Service Bulletins

Rolls-Royce Silver Cloud Bentley 'S' Type

**Printed and Published by
Rolls-Royce Motor Cars Limited
Crewe Cheshire
CW1 3PL England**

Fig.1

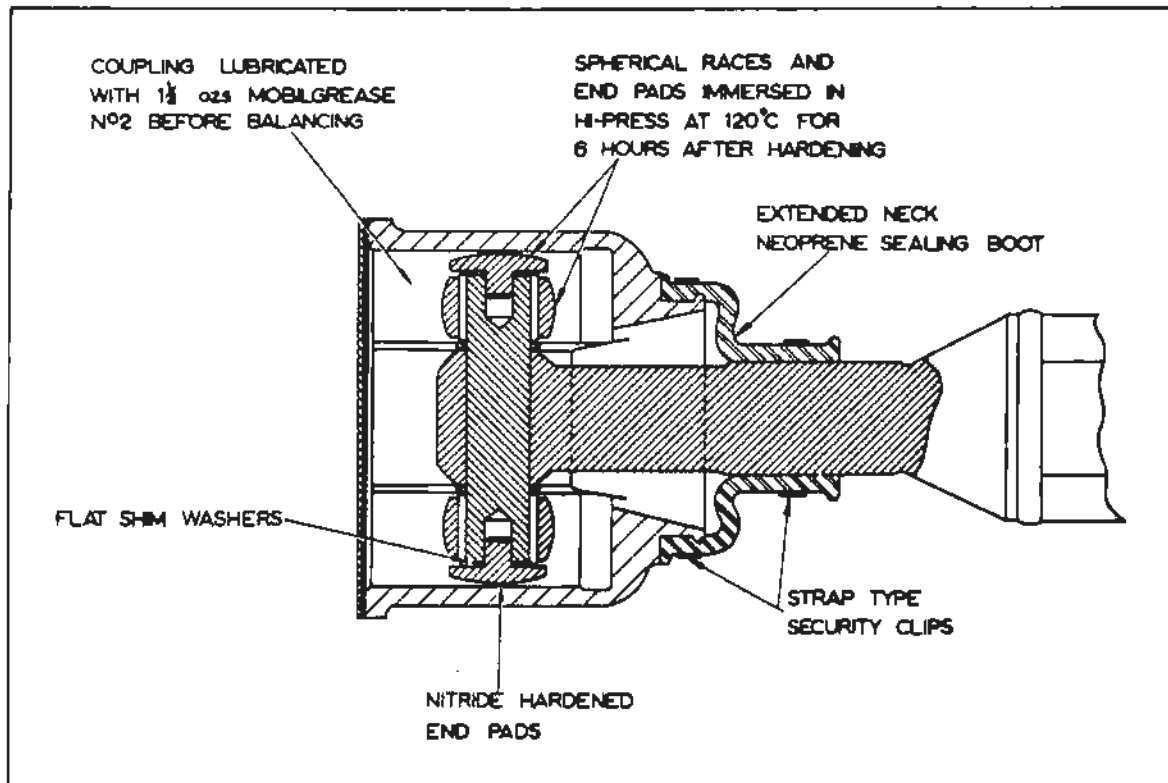
Fig.1 shows at a glance the modifications incorporated on the front universal coupling used on 'S' Type cars in current production

Early development work was, therefore, directed towards increasing the mechanical strength of the sealing boot. This was achieved by altering the elastomer specification from rubber to neoprene together with detail dimensional changes. The dimpled band security clips Part Nos UG 1653/4 remain unchanged.

A redesigned sealing boot of non-Convolute form was produced to accommodate the change of lubricant and to ensure that it is confined within the outer lobes of the coupling body. An early alteration in the synthetic rubber specification of the redesigned boot to neoprene was found necessary to overcome initial manufacturing difficulties. At the same time, the dimpled band clip Part No. UG 1653 originally retained for use with this boot together with the reduced diameter dimpled band clip Part No. UG 3021, were superseded by 14 S.W.G. wire type security clips Part Nos UG 3522/3.

As heat is necessary to obtain the full benefit of using an Extreme Pressure lubricant, the spherical races and end pads are now immersed in Hi-Press Oil at 120 C for 6 hours after hardening. This pre-treatment is considered preferable to relying on local heat generation in service and should prevent any fretting occurring at the contact areas of the spherical races and end pads. In addition, a change in the material specification from a case hardening to a nitriding steel has been made for the end pads

Fig.1.

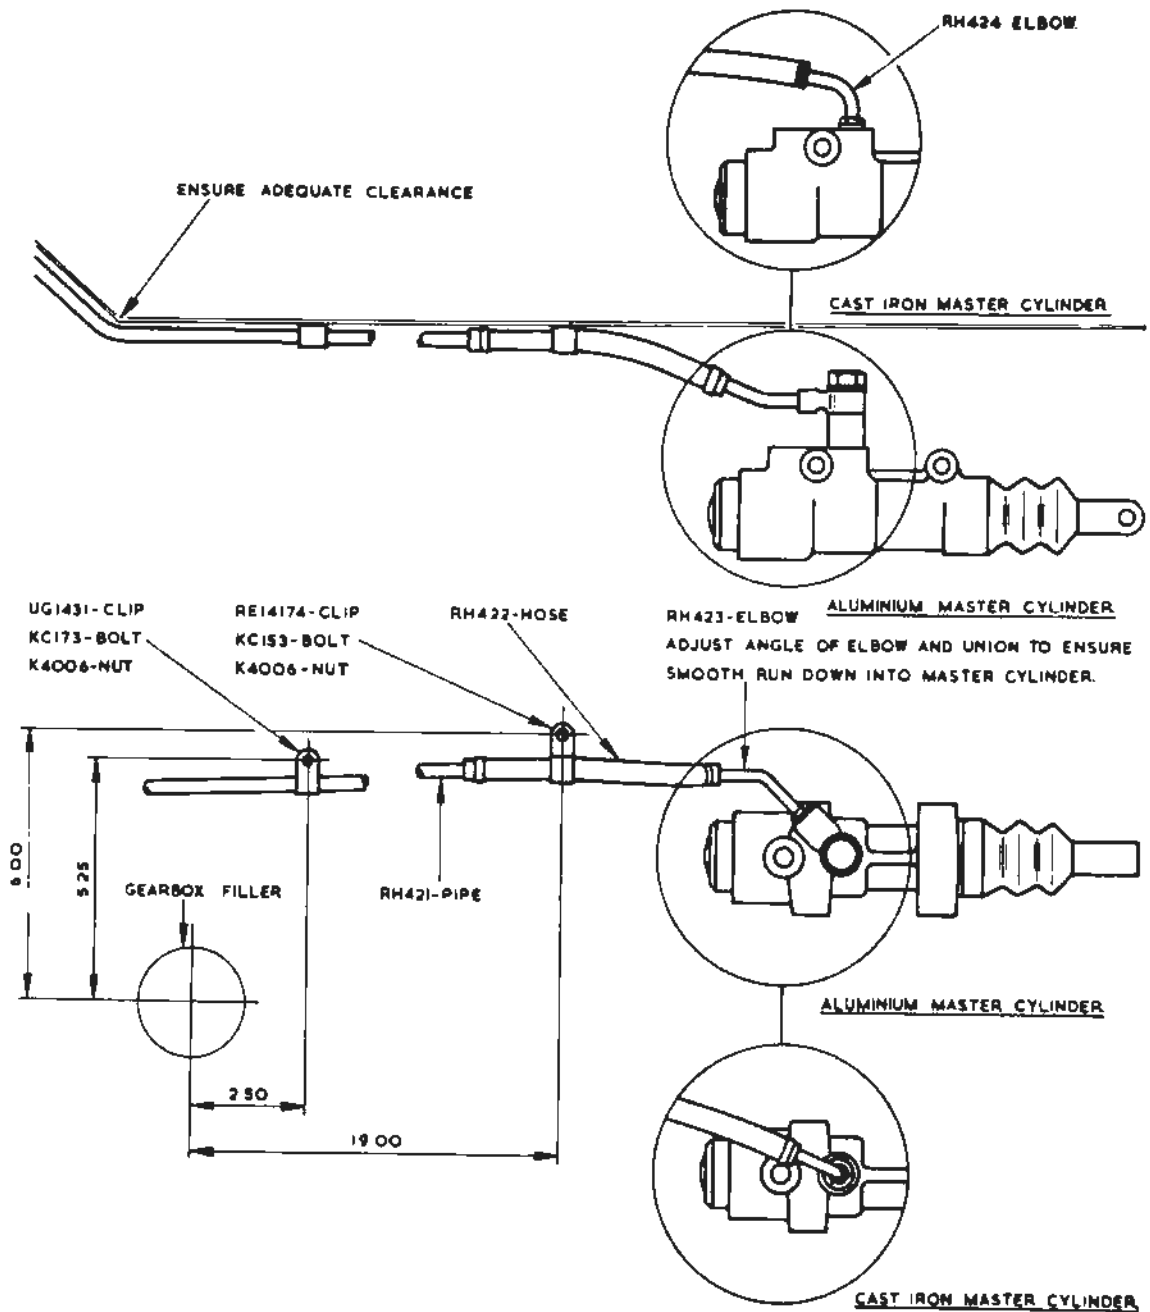
Remove the wiring loom fitted along the right hand undersurface of the floor from its clips and ease it towards the side of the car to avoid damage when drilling the two 3/16" dia. holes in the floor which are to be marked and drilled as indicated to take the new hose clip securing setscrews (Fig.1). Drill the 1/8" dia. hole in the right hand valance as indicated (Fig.2).

Screw the master cylinder union nut finger tight and adjust the pipe for length to provide adequate clearance at the toe-board as indicated (Fig. 1) and for angular displacement so that the pipe will align correctly at the master cylinder elbow and also at the steering column seal clip fixing (Fig. 2). All adjustments for length and angle are to be made at the point previously described.

Fig. 2.

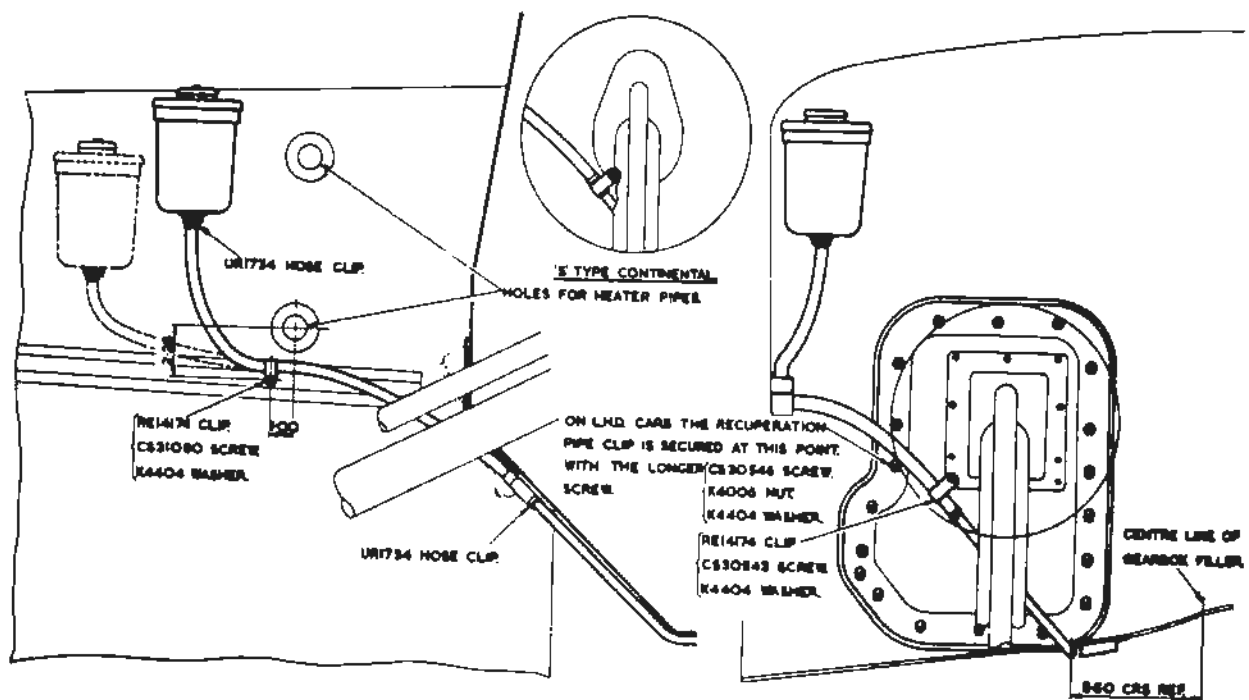
Inspect the pipe assembly to ensure that there is a smooth and continuous rise from the master cylinder to the toe-board. The master cylinder elbow union nut for the cast iron master cylinder is left slack and the "banjo" union on the aluminium master cylinder is slackened to permit this final adjustment.

Check Valve in Position.

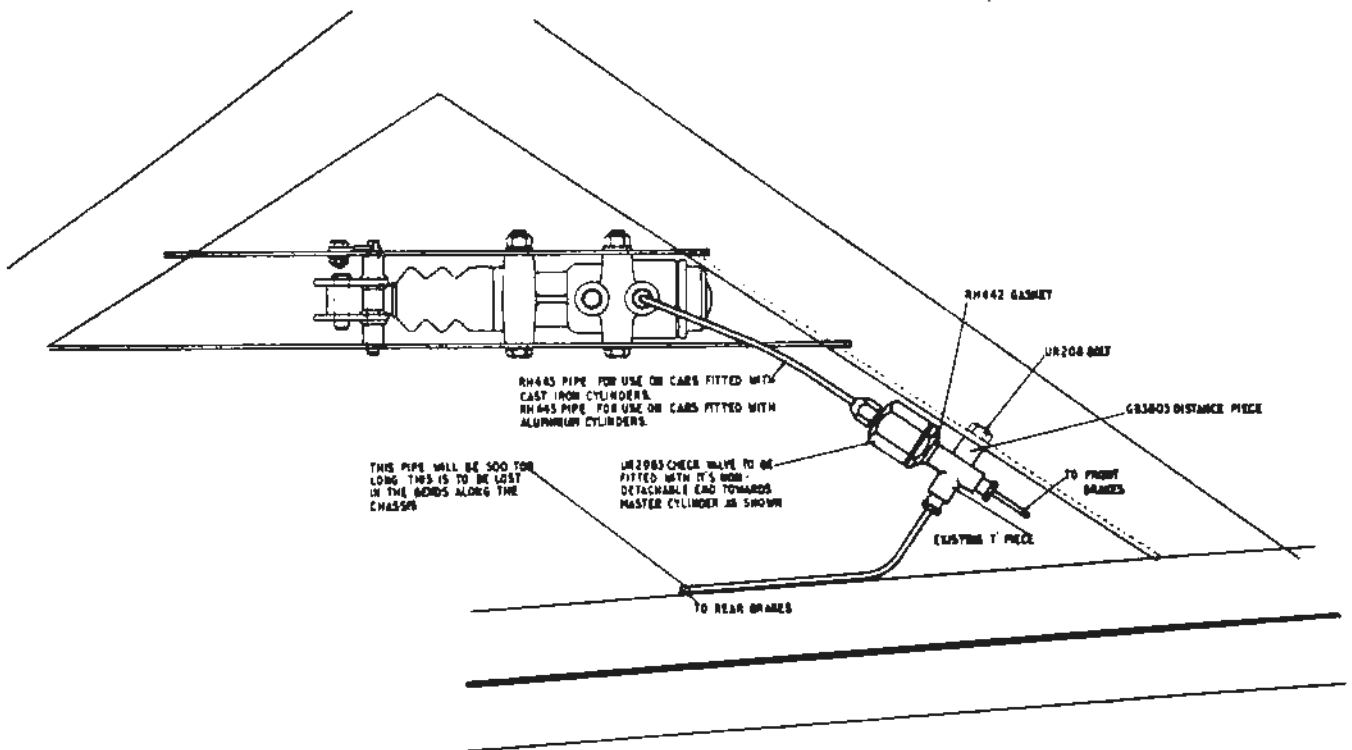
The drawing below illustrates the method of installation. The existing pipe from the master cylinder to the junction on the "X" frame member should be removed.

Fig.1. Rear Axle Torque Arm.

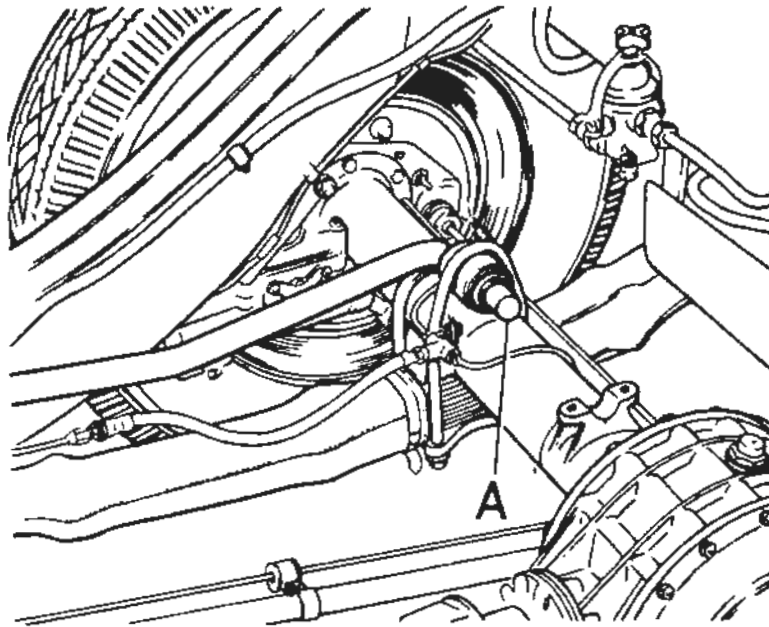
The "Z" bar is to be cut 1" inboard of the outer Silentbloc bush on the axle (A, Fig.1.) and the inner bush mounting discarded. The end of the "Z" bar is to be filed smooth, the edges rounded and finally painted with a first quality air drying chassis black.

FIG. 1 EARLIER ASSEMBLY

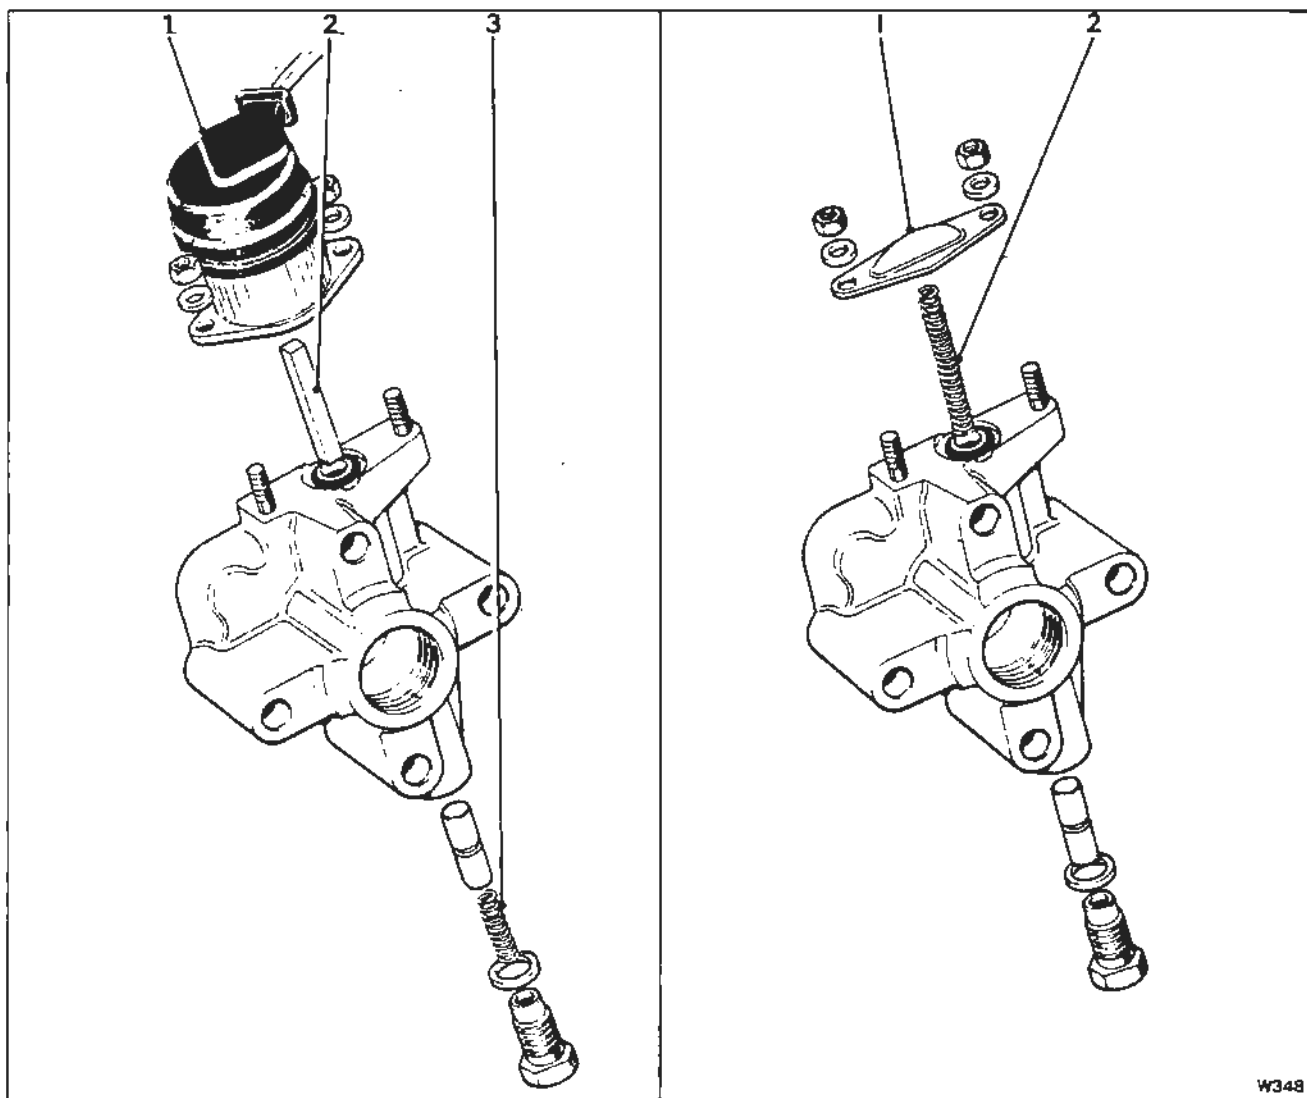
- 3 Disconnect both the wires to each rear damper solenoid and tape them back into the loom.
- 4 Remove the ride control solenoid (see Fig 1)
- 5 Remove the solenoid spring (see Fig 1)
- 6 Remove the slow leak push rod (see Fig 1)
- 7 Fit the new spring in place of the slow leak push rod (see Fig 2)
- 8 Fit the blanking plate in place of the solenoid (see Fig 2)

Part No	Description
UR 1509	Blanking Plate
UB 15301	Spring

Fig.1.

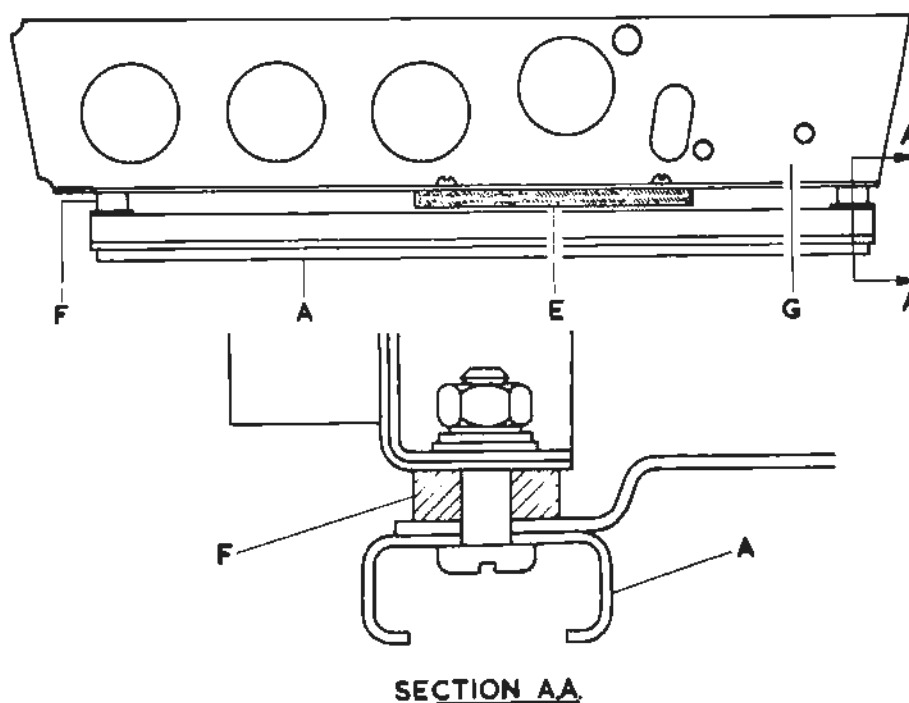
A rattle from the seat runner assembly can be due either to the woodscrews and setscrews securing the seat slides to the seats becoming loose owing to shrinkage of the hardwood mounting, or, the setscrews securing the slides to the floor becoming loose due to the localised setting of the leather trim around the screw holes in the hardwood mounting blocks during service.

The seat should be demounted and the seat slides removed. Replace the existing hardwood mounting with the two aluminium distance pieces and the short hardwood block using the existing woodscrews and setscrews (Fig.1).

Fig.2.

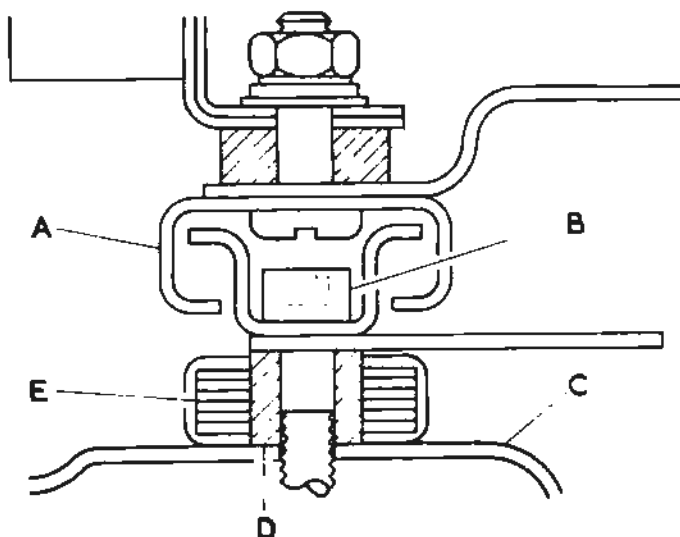
The floor seat slides are then removed, the holes in the existing hardwood mounting block widened out to .500" and the mild steel bushes pressed into position. The seat slides are then refitted using .250" UNF Allen screws (B, Fig.2) instead of the existing setscrews, which will provide greater security, (Fig.2).

FIG. 1.

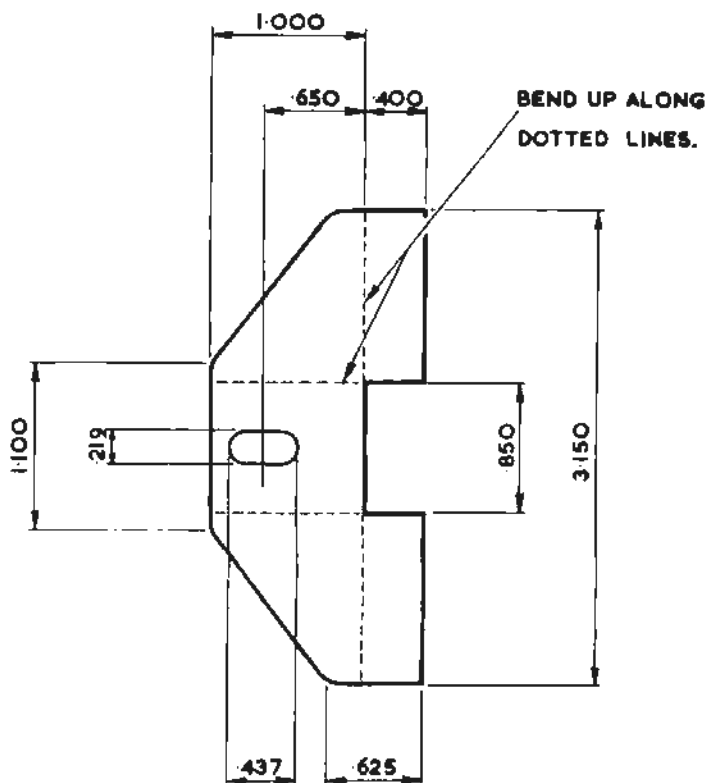
In the event of new channel assemblies not being easily available, Retailers may manufacture new brackets in accordance with the following illustrations and dimensions.

- (a) Cut off existing bracket as shown in the inset.
- (b) Make up new brackets as detailed in Fig.1 using 18 gauge sheet steel, and bend as indicated.
- (c) Position on channel and weld all round as shown in Fig.2.
- (d) Clean up assembly and paint with a high quality Black Enamel.
